35/13-06FF 3706 BRADLEY LA
Chevy Chase Village Historic District

HISTORIC PRESERVATION COMMISSION STAFF REPORT

Address: 3706 Bradley Lane, Chevy Chase **Meeting Date:** 11/15/06
Resource: Contributing Resource **Report Date:** 11/08/06
Chevy Chase Village Historic District **Public Notice:** 11/01/06
Applicant: Alex and Catherine Triantis
(Roselie Enriquez, Agent)
Review: HAWP **Tax Credit:** N/A
Case Number: 35/15-06FF **Staff:** Michele (aka) *Del Poston*
PROPOSAL: Additions *and Jim's*
RECOMMENDATION: ~~Continuance~~ *Unanimous*

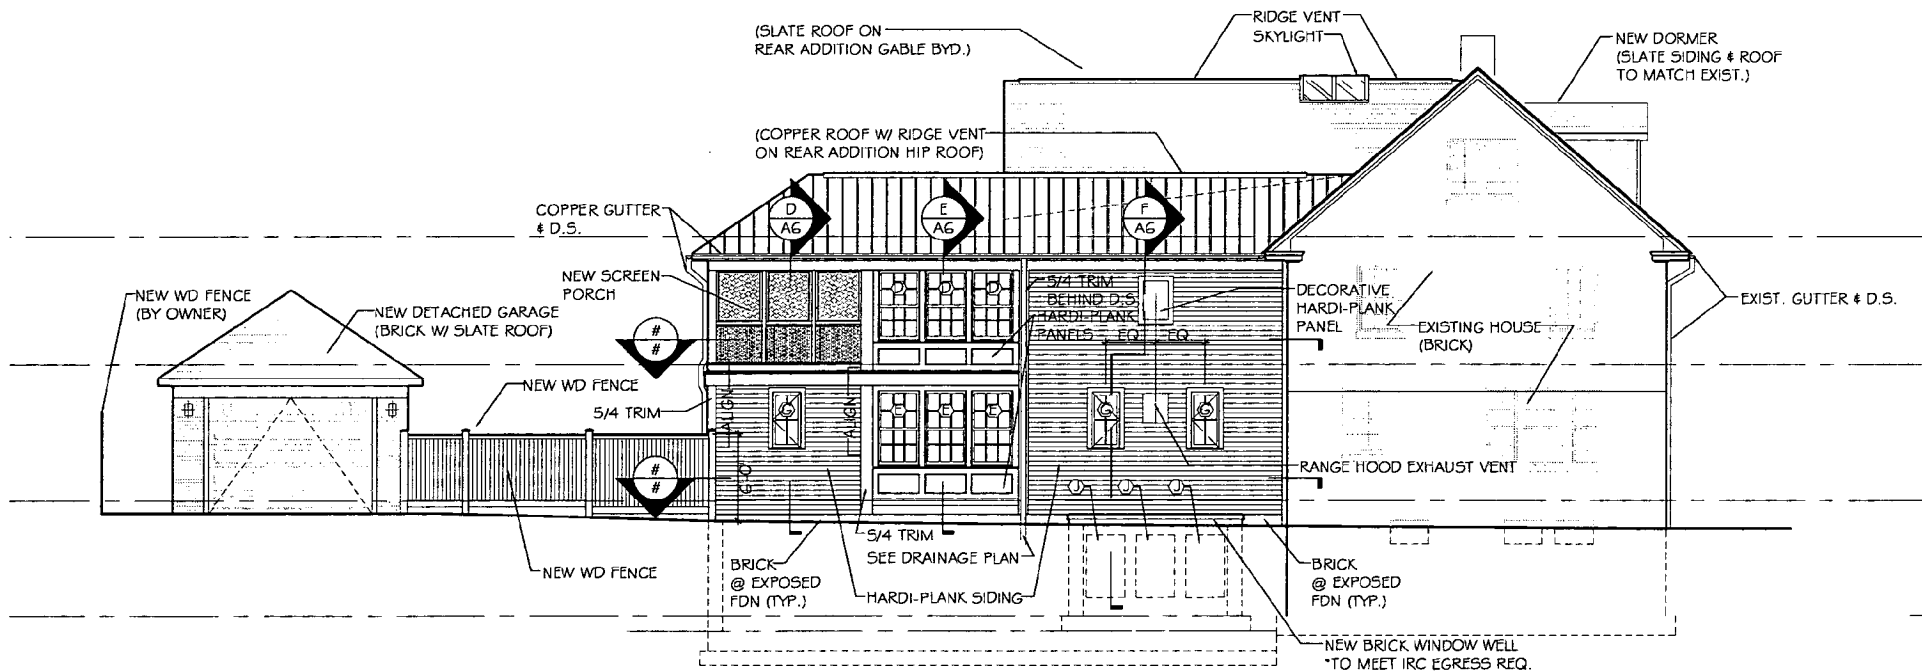
I have a quick question for you regarding the design of our addition on 3706 Bradley Lane. The HAWP was recently approved and, as we're preparing the permit drawings, we saw an opportunity to simplify the 2 window wells that we originally proposed on the eastern side yard. In our approved design, we proposed (2) 3'x3' window wells w/ individual windows in each. For ease of construction, we'd like to simply combine the two window wells into one large window well. This also enables us to add a window between the two, originally isolated, windows. Please note that these windows are completely below grade and located on the side yard (shared driveway side). If we proceed with this revision, will it require another review from historic?

(I've attached the revised side elevation and the window well has been dashed-in below grade. Again, please note how the windows are completely below grade.)

If there are no changes to exterior elevations, I don't see why we would need to stamp the revised drawings. However, if you run into a problem with DPS or the Village where they need to see our stamp on something that you have submitted, let our office know. I am out of town next week but I will put this in the file in case you call another staff person.

A PROPOSED SITE
5 1/16" = 1'-0"

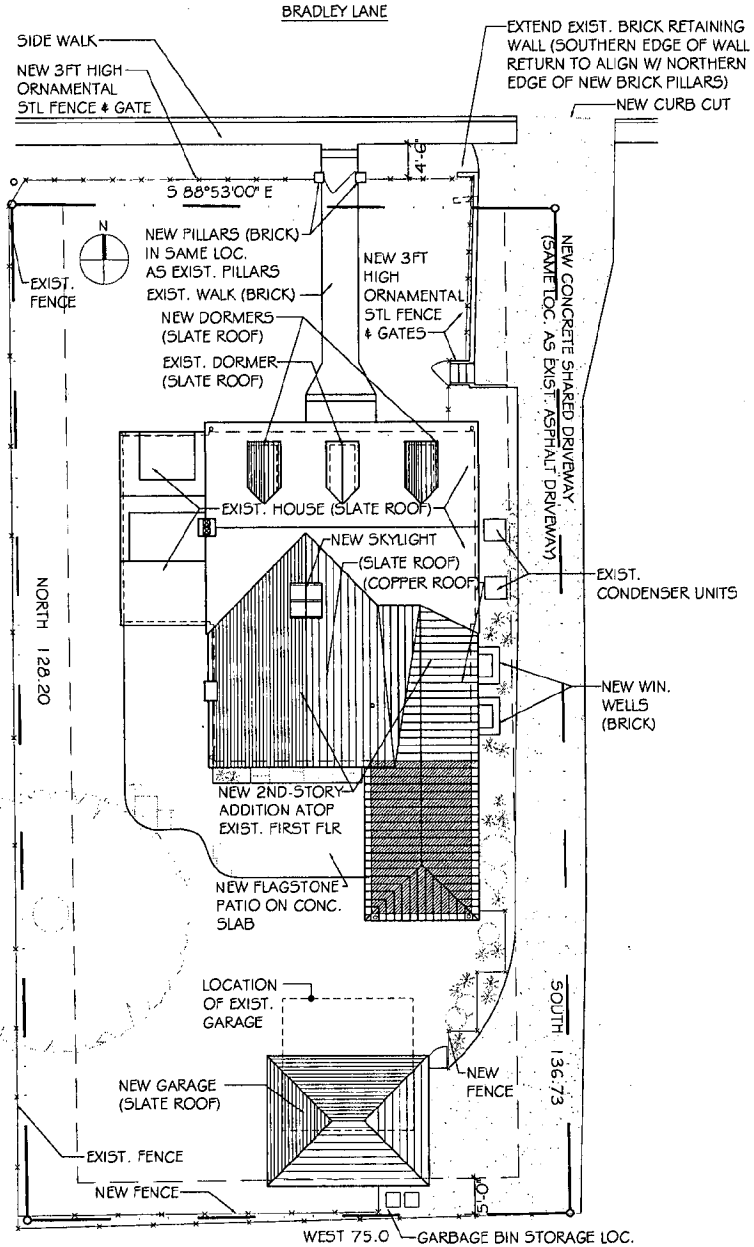
1. Re-design the rear additions by removing the rear ell's footprint. The goal is to preserve the maximum amount of open space in the rear yard. *near porch to be. Delete screen porch ~ approx 12'.*
2. The design of the new pillar will replicate the original, unless the applicants can provide the Commission with information documenting that these pillars are not original to the site. *current owners built piers in 1980.*
3. The garage doors to be installed on the new garage will be fabricated out of wood.
4. Original dormer's material will not be changed to Hardi-plank.
5. A tree protection plan for this project will be designed and approved by Chevy Chase Village arborist. This plan will be implemented prior to any work beginning on the property.
6. ~~The~~ *NEW* proposed 6'6" high fences will not exceed 6' in height.

1. The proposed one-story screen porch to be located on the west elevation is deleted from the design.
2. The proposed addition's west wall will be inset approximately 12".
3. The new garage doors to be installed on the new garage will be fabricated out of wood.
4. The original dormer's material will not be changed to Hardi-plank.
5. A tree protection plan for this project will be designed and approved by the Chevy Chase Village Arborist. This plan will be implemented prior to any work beginning on the property.
6. The proposed 6'6" high fences will not exceed 6' in height.
7. The new dormers will be slate.

A SIDE ELEV. (WEST)
3 1/8" = 1'-0"

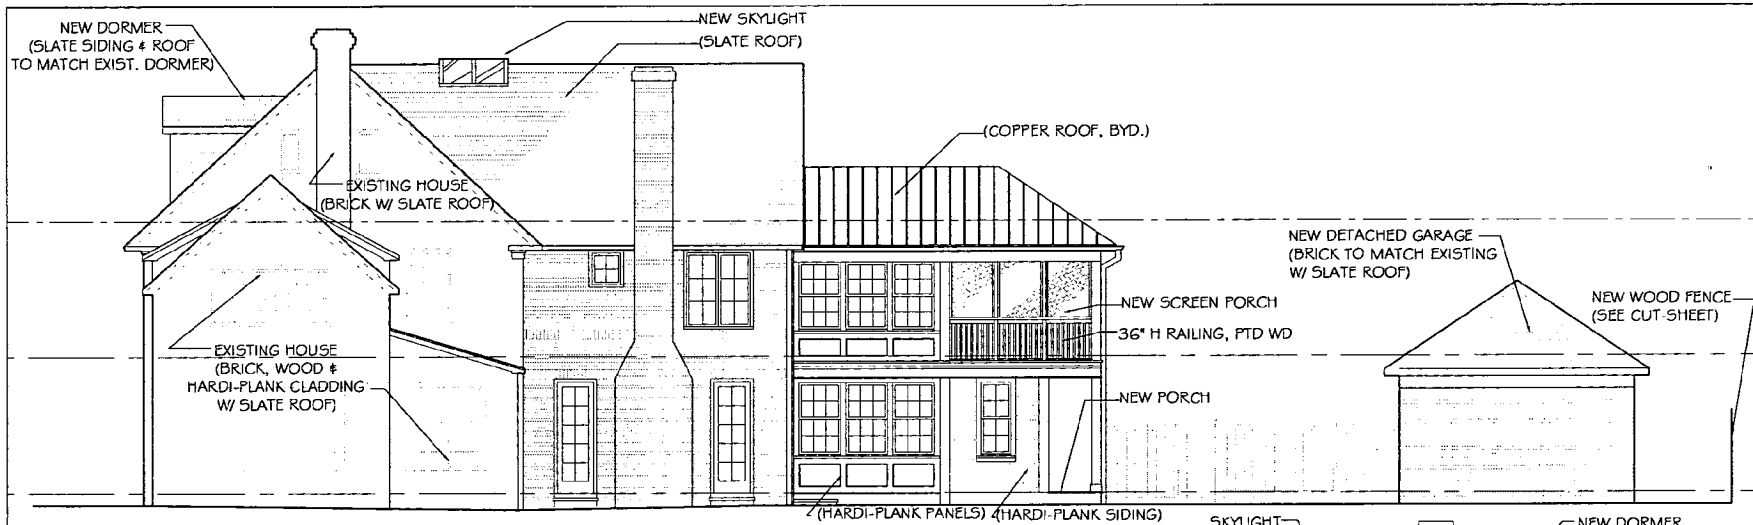
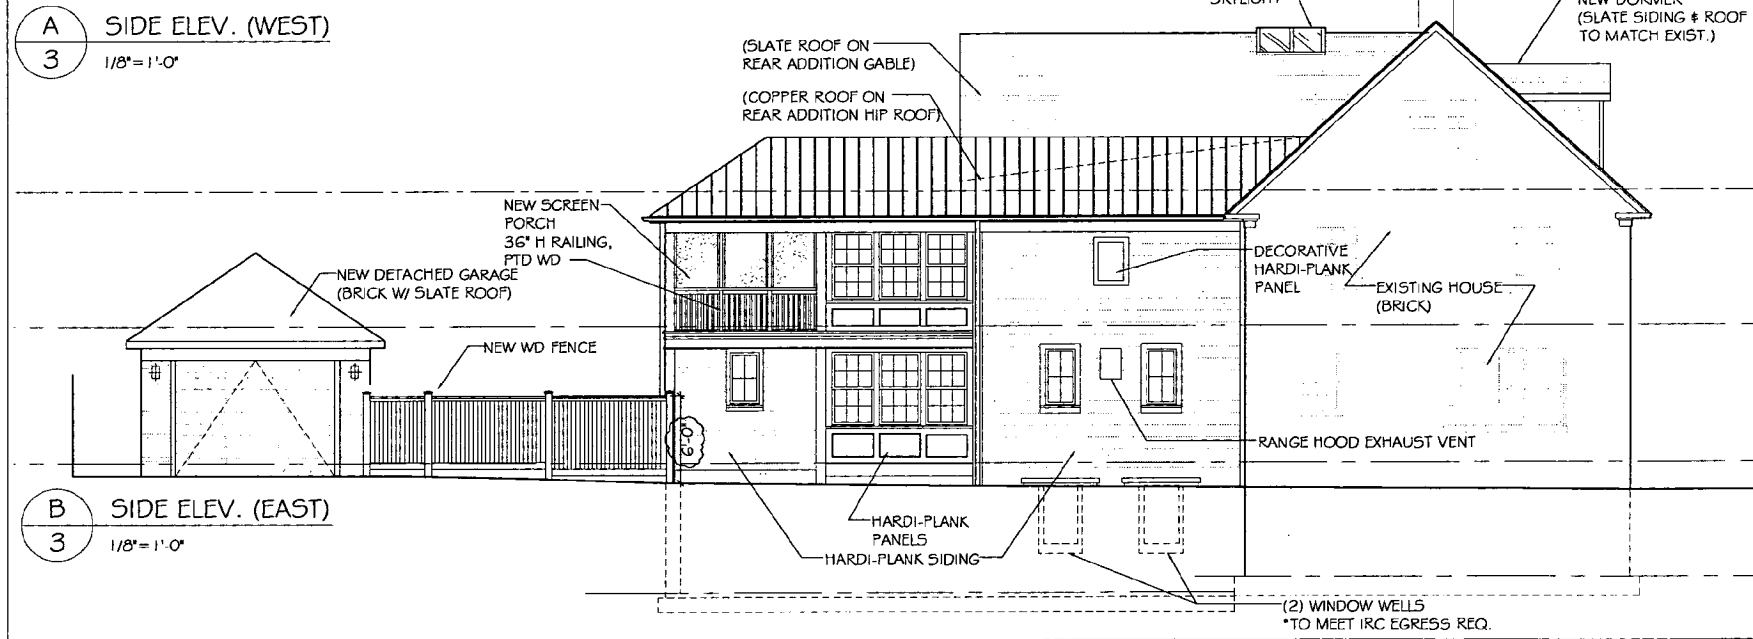
5. Lower Rear addition gable roof so that new ridge is 12" below existing gable ridge:

Our original design proposed matching the slope of the new gable roof to that of the existing roof. If we retain this strategy and have the 6" massing set-back described above, the ridge of the new roof will fall 10" below the existing ridge. We feel that retaining the same slope as the existing roof out-weights the 2" dimensional discrepancy.

A SIDE ELEV. (WEST)
2 1/8" = 1'-0"

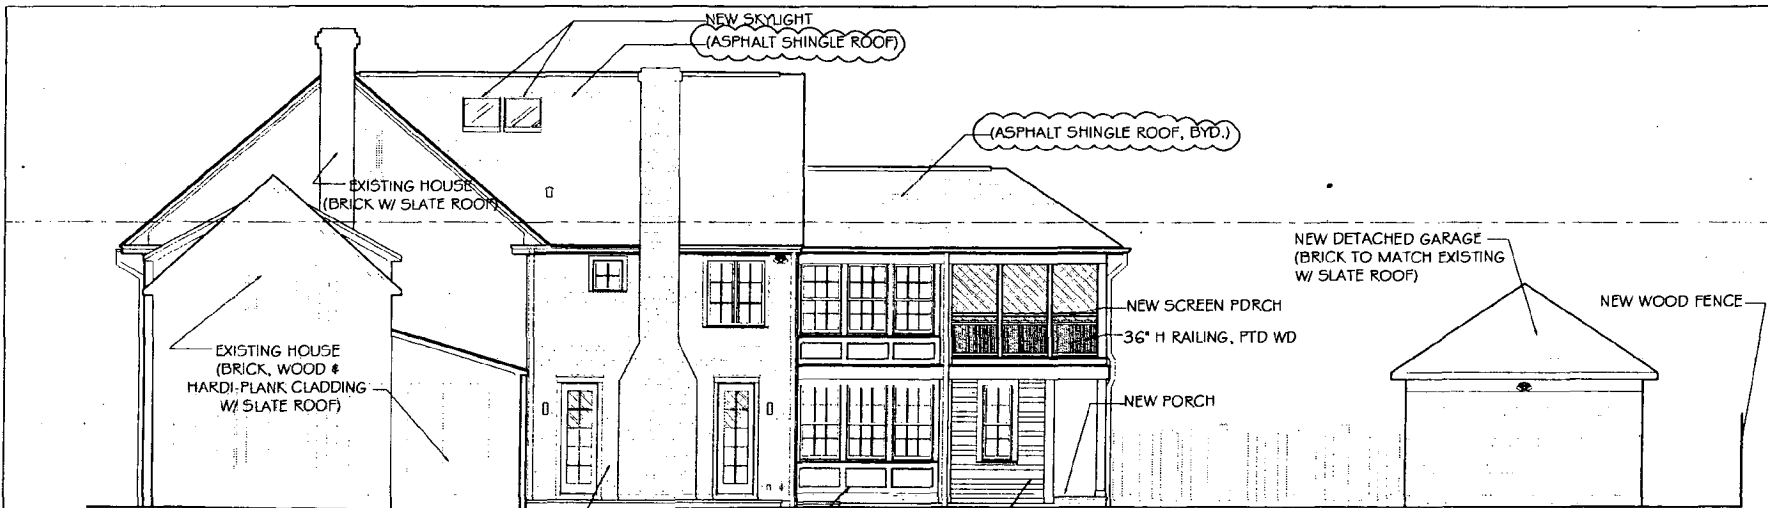
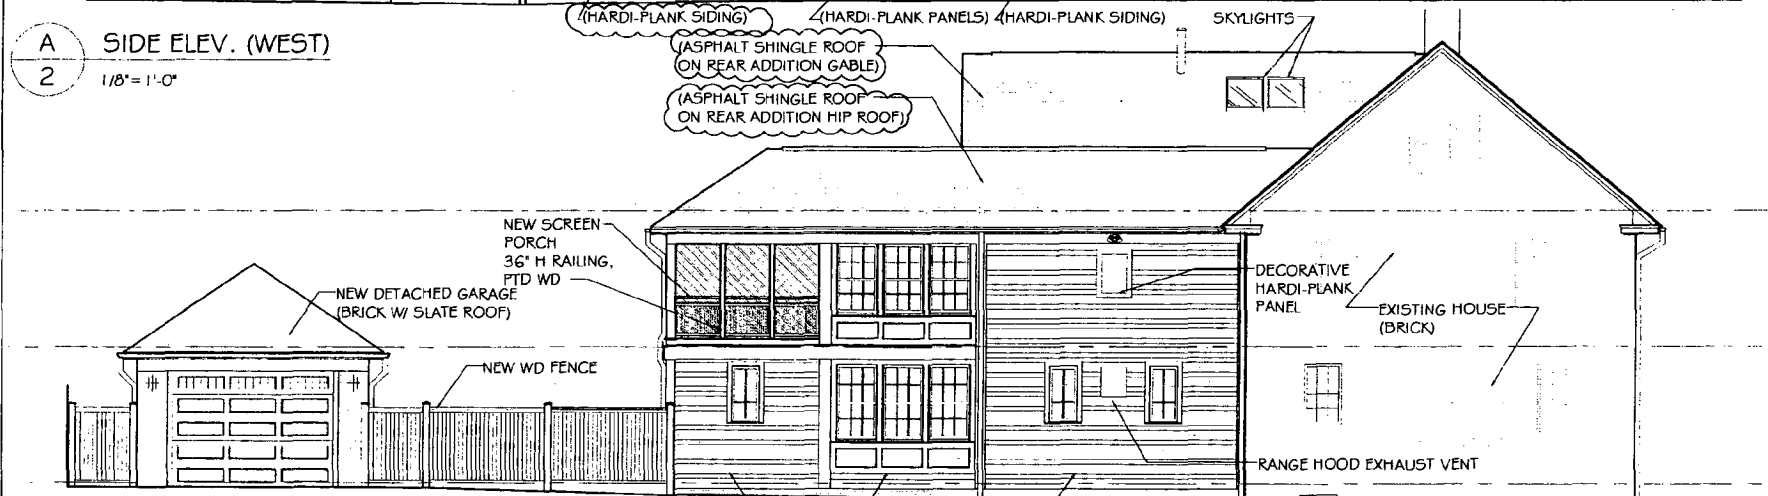
1. CHANGE IN EXTERIOR WALL MATERIAL AT 2 ½ STORY REAR ADDITION

In an effort to reduce cost, we request that the commission approve the use of Hardi-Plank siding on the new 2 ½" story rear addition (originally proposed as brick veneer).

2. CHANGE IN ROOFING MATERIAL AT REAR ADDITIONS

In an effort to reduce cost, we request that the commission approve the use of architectural asphalt shingles on the new 2 ½" story addition (originally proposed as slate) and the new 2 story wing addition (originally proposed as standing seam metal).
